Response to Request for Review for:

"Zilenghe 24MW Hydropower Project in Yunnan Province" (Ref. no. 2164)"

Figure 1. IRR of total investment sensitivity analysis

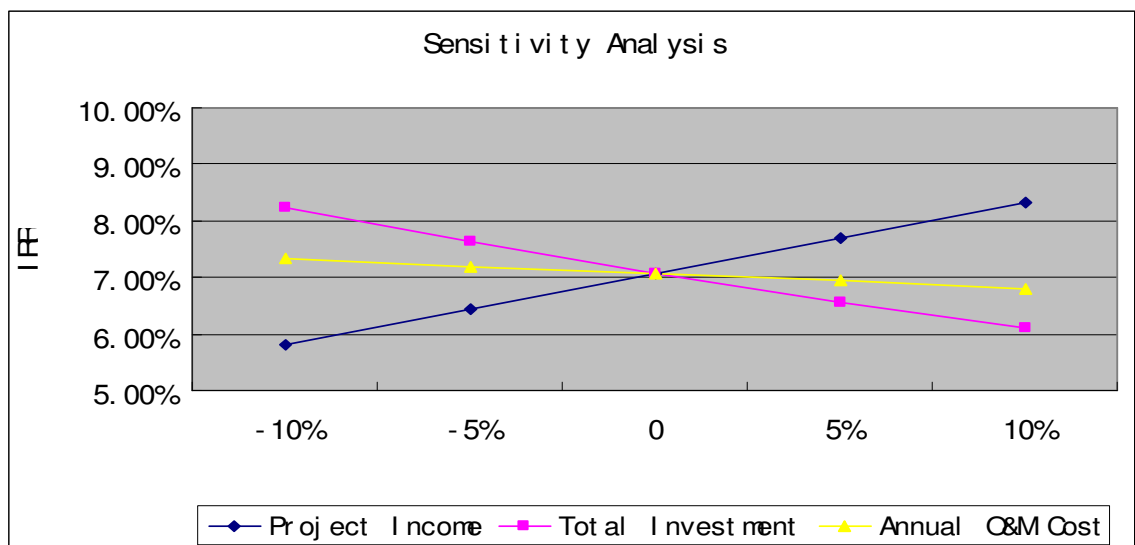
Request for Review	
Issue 1	
Issue raised by EB Members / DNA	“1. The PP/DOE are requested to clarify whether expenses incurred before the restart of construction are in line with the requirements of EB 41, Annex 45 paragraph (7) guidance.”

Assuming that the above three factors fluctuate within the range¹³ of -10%~+10%, the corresponding impacts on the IRR of total investment of the Project are shown in Table 2 and Figure 1.

As shown in the sensitivity analysis above, even the fluctuation range of the factors reach $\pm 10\%$, the project IRR of the Project could not reach the benchmark and the conclusion regarding that the Project is financially unattractive is still tenable.

<p>Response of DOE</p>	<p>The referenced EB guidance (EB 41, Annex 45, paragraph 7) requires the reflection of recoverable value of assets in the economic decision making context. The PP intends to meet the above mentioned requirement by issuance of a slightly revised investment calculation and provision of further evidences. In the course of reviewing all available documentation the following has been identified:</p> <ul style="list-style-type: none"> • Recoverable value of assets, being the fair value of assets for which capital cost incurred prior to the revised project activity starting date are deducted from the total investment for this CDM project activity. • The investment incurred before recommencement of construction was 0.7876 million RMB of which 100% have been deducted from the total investment cost for the project activity. • According to Damage Assessment Report issued by Hunan Chenzhou Yangguang Hydropower Supervising Consulting Co., Ltd., investment prior to the revised project starting date comprises 0.5712 million RMB for tunnel construction and 0.2164 million RMB for auxiliary projects. • Since the deduction of 0.7876 million RMB represents the total investment prior to recommencement of the project implementation, even though only 0.2164 million RMB are recoverable, this calculation approach is conservative. • The suspension period due to the difficult geological situation was from May 21, 2006 to August 25, 2006. Potentially changes of recoverable values of assets in about 3 months are assessed to be insignificant. <p>As a result of the revised investment calculation the financial parameters, i.e. the project IRRs (with and without consideration of sales of CERs) of the CDM project in question have slightly risen. The rise from 6.99% up to 7.07% without revenues from sales of CERs and with revenues from sales of CERs from 12.87% to 12.98% improves the project's financial viability slightly and does not violate the benchmark value of 10%. This situation remains even if input values "project income", "total investment" and "Annual O&M cost" fluctuate within the range of -10%~+10%.</p> <p>Thus the project was still economically unattractive at the point of decision to proceed with its implementation under the assumptions explained above and provided in the investment analysis.</p> <p>Hence, TÜV NORD concludes after a precise validation of the submitted documentation and background information that the requirement of EB 41, Annex 45 paragraph (7) guidance is fulfilled.</p>
